Proposed Goulburn River Solar Farm

Addendum

LANDSCAPE CHARACTER AND VISUAL IMPACT ASSESSMENT

DOCUMENT NO.: 21523

Figure 2-1: Location of Proposed Amendments

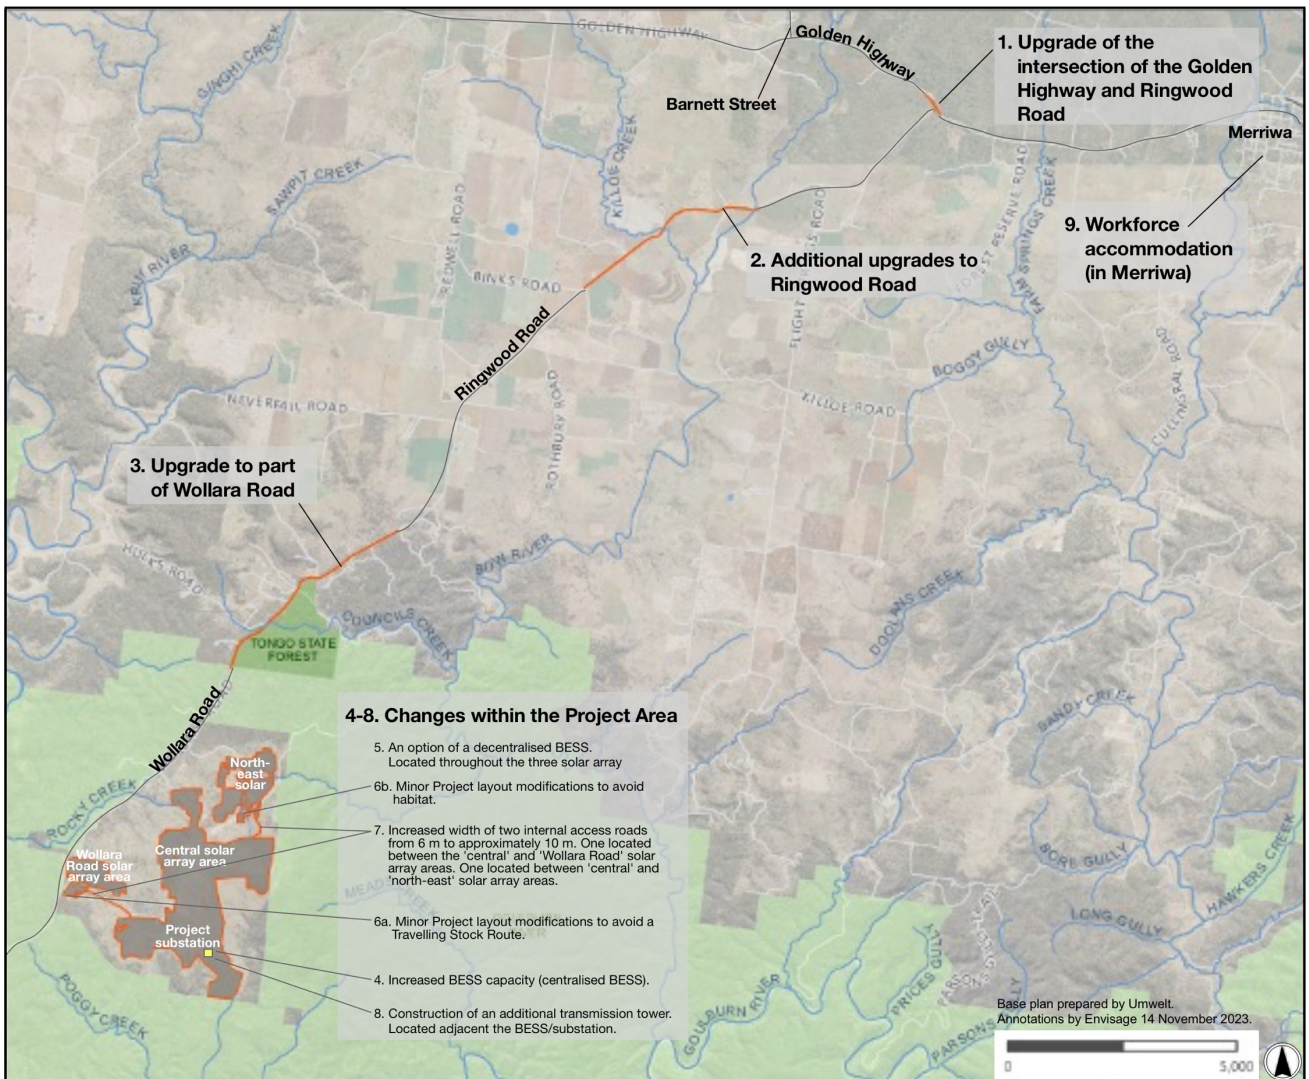
- 1 Upgrading the intersection of the Golden Highway and Ringwood Road.
- 2 Additional upgrades to Ringwood Road.
- 3 Upgrading parts of Wollara Road.
- 4 Increasing BESS capacity (centralised BESS).
- 5 The option of a decentralised BESS (and the choice to host both centralised and decentralised BESS units)
- 6 Minor Project layout modifications (which, together, reduce the size of the development footprint by around 7 ha), being:
 - a. Re-aligning the Project Area to avoid a Travelling Stock Route.
 - b. Relocating solar arrays within the development footprint to avoid habitat.
- 7 Increasing the width of two internal access roads to approximately 10 m.
- 8 Constructing an additional transmission tower adjacent to the BESS/substation.
- 9 Revised approach for workforce accommodation.

The location of proposed amendments is shown in Figure 2-1. Visual changes associated with the Amended Project (compared to the EIS Project), are described in Table 2-1.
